5F2-A Stock & current configuration

5F2-A Modified for use with Solid State rectifiers & Pi filter.

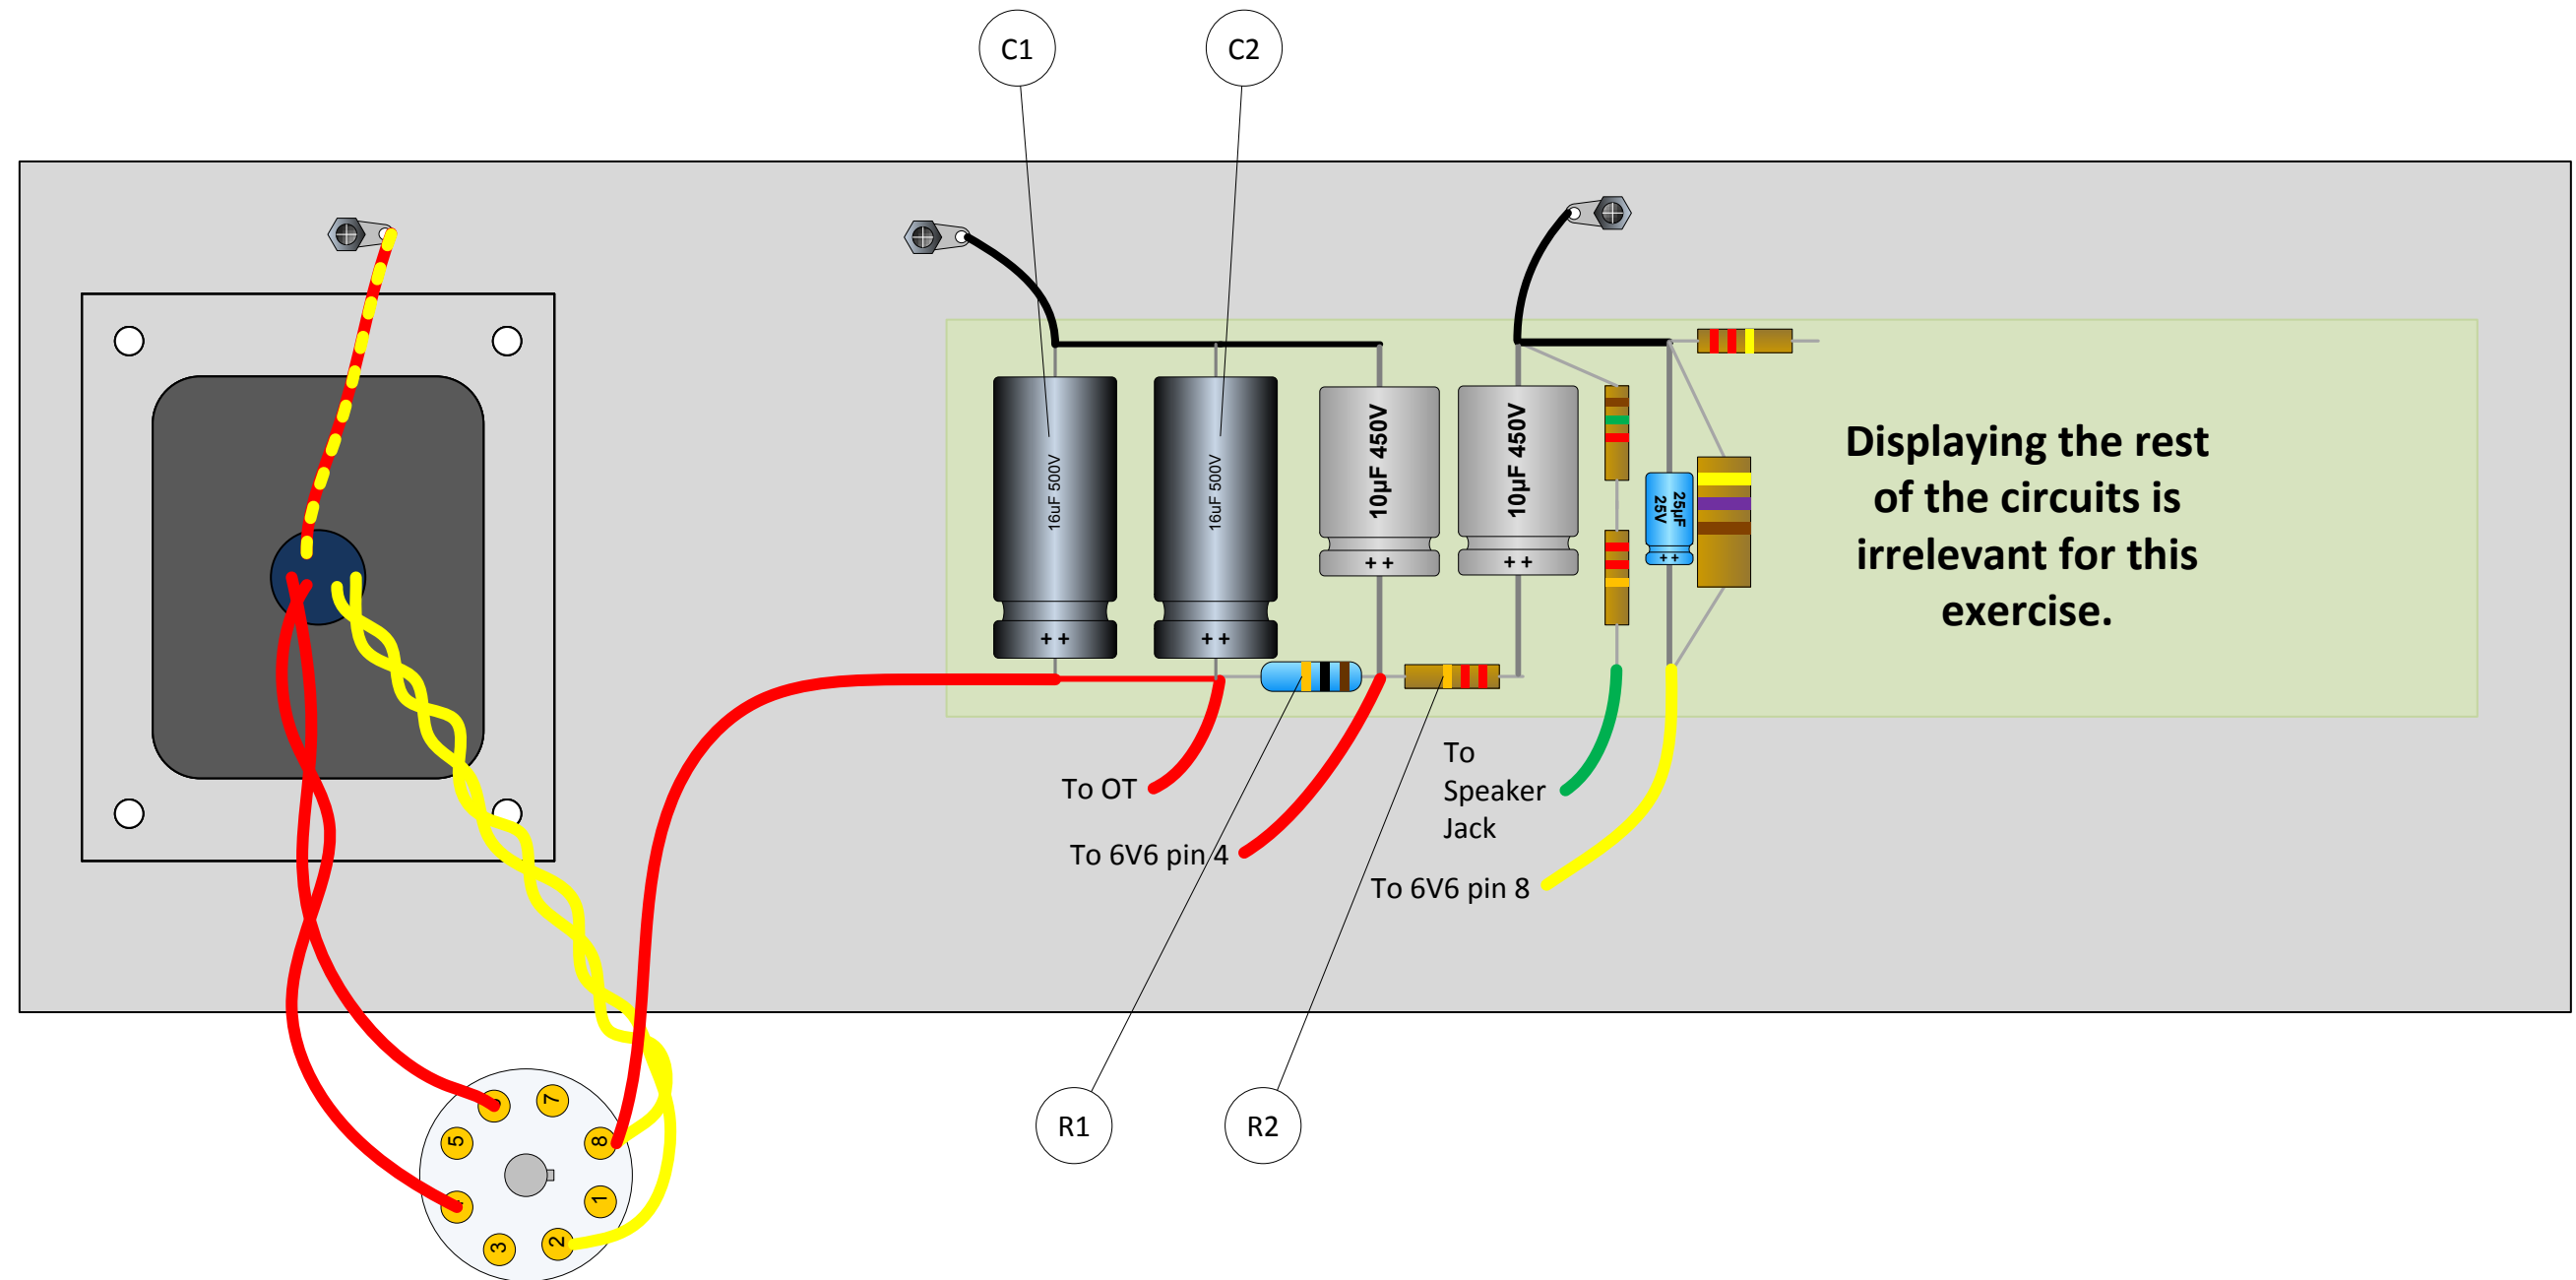
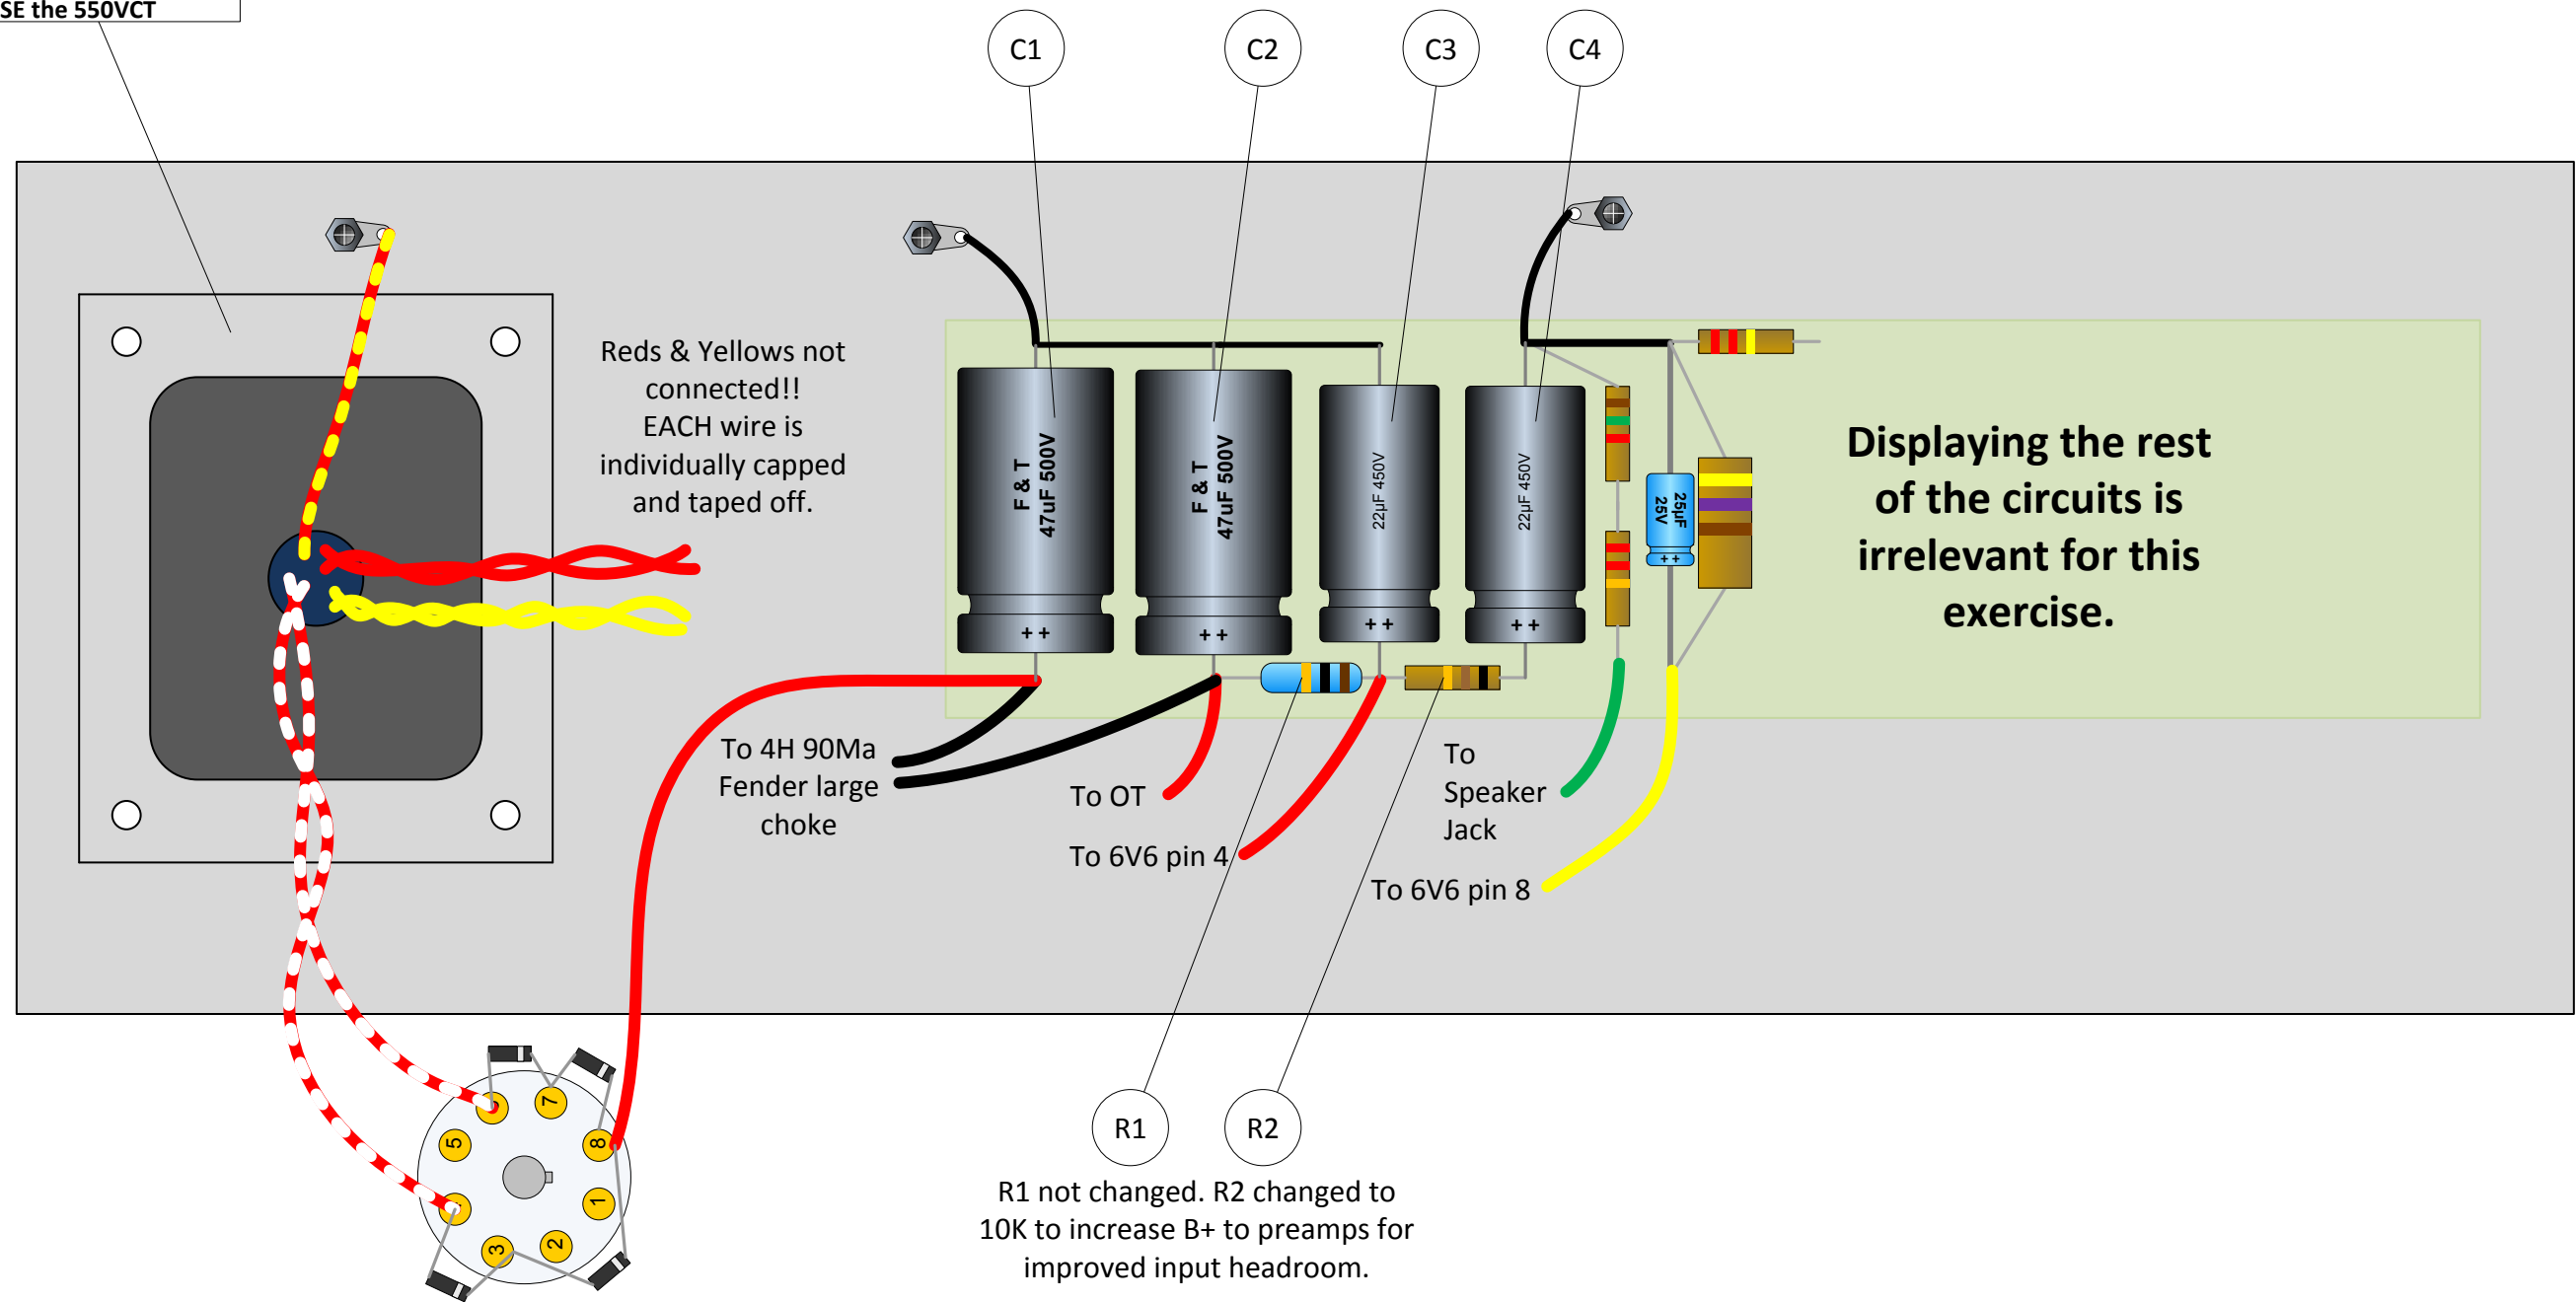
Power transformer replaced
with ClassicTone 40-18027
650VCT & 550VCT
USE the 550VCT

Replace C1 & C2 with 47uF
450V or 500V parts.

Replace C3 & C4 with 22uF
450V or 500V parts.

Remove 5Y3 rectifier &
install 4x 1N4007 silicon
diodes as shown.
